RE: ENGINEER'S CERTIFICATION FOR MERIDIAN BUSINESS PARK, LOT 15, 7400
MERIDIAN PLACE (K-10/ D035), ENGINEER'S STAMP DATED 10/26/99,
CERTIFICATION DATED 10/20/2000.

***RE: MERIDIAN BUSINESS PARK, LOT 15 (K10-D35). GRADING AND DRAINAGE
PLAN FOR SITE DEVELOPMENT PLAN FOR BUILDING PERMIT AND
BUILDING PERMIT APPROVALS. ENGINEER'S STAMP DATED OCTOBER 29,
1999 WITH Resubmittal STAMPED DECEMBER 16, 1999.***

GRADING AND DRAINAGE PLAN - LOT 15

MERIDIAN LOT 15

GRADING & DRAINAGE PLAN

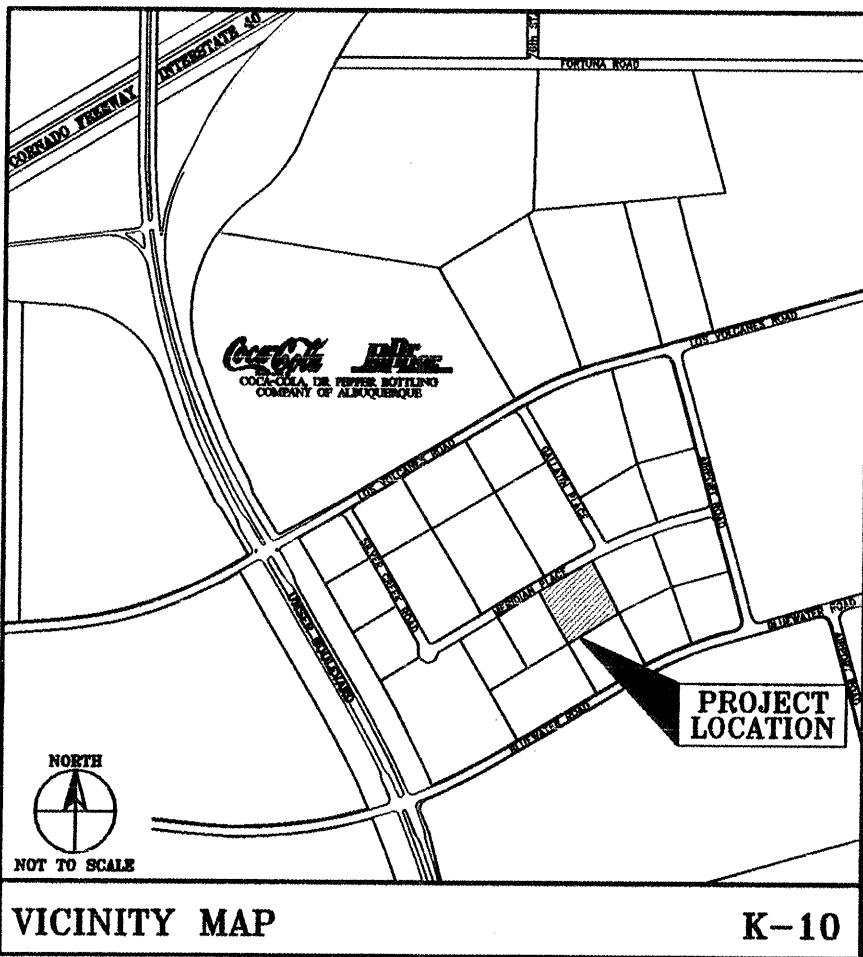
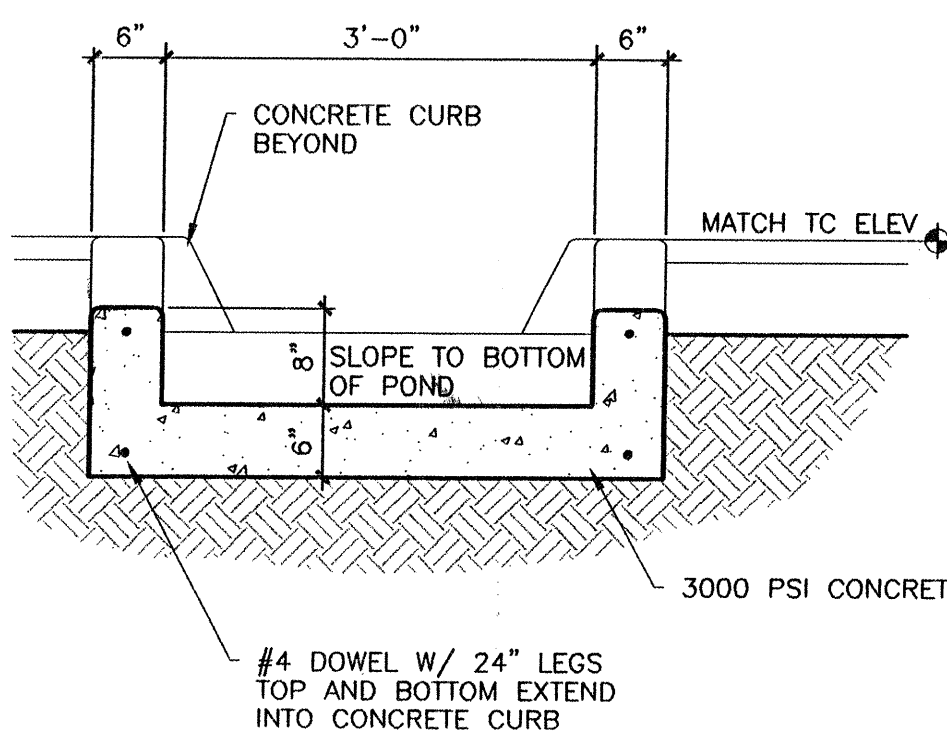
Although the system is private, maintenance, especially of the orifices, is a concern. The owner should be apprised of that need so that the system will continue to function as you planned.
